BCA ASSESSMENT REPORT

**Project Ocado, Horsley Business Park
Cowpasture Rd, Wetherill Park**

**Prepared For:
Charter Hall & FDC**

Revision 2

Figure 1 – Perimeter Vehicular Access per BCA C2.4.

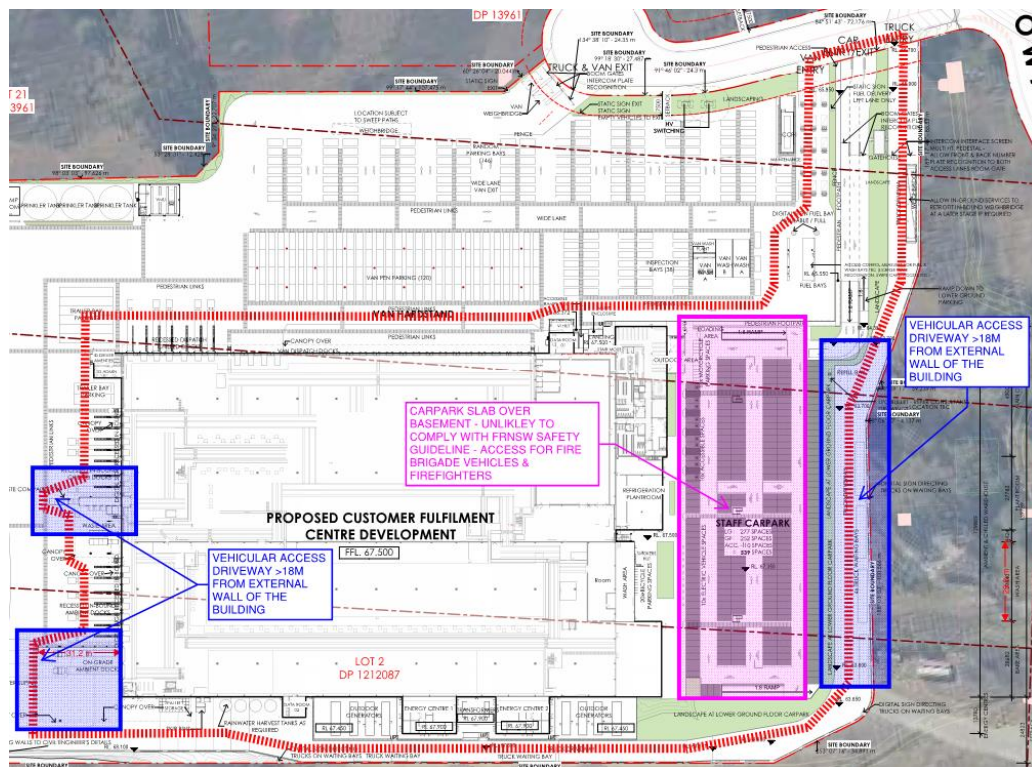
Comments: The proposed warehouse building complies with the provisions of C2.4 with the exception of the areas marked in blue on the site plan below that are required to be addressed as a performance solution by the Fire Safety Engineer:

- Vehicular Access is greater than 18m from the eastern external wall of the Warehouse Building along the eastern elevation.
- Vehicular Access is greater than 18m from the south eastern corner of the Warehouse Building around the On-Grade Ambient Dock Canopy.
- Vehicular Access is greater than 18m from the western external wall of the Warehouse Building along the western elevation around the Garbage Waste Compactor.
- Vehicular Access is discontinuous in the NE corner of the building.

Note: Vehicular Access onto/over the Staff Carpark building on the eastern side of the building is not likely to comply with the FRNSW Vehicular Access guidelines (in regards to load-bearing capacity requirements and turning paths) and as such it has not been considered in the perimeter vehicular access assessment.
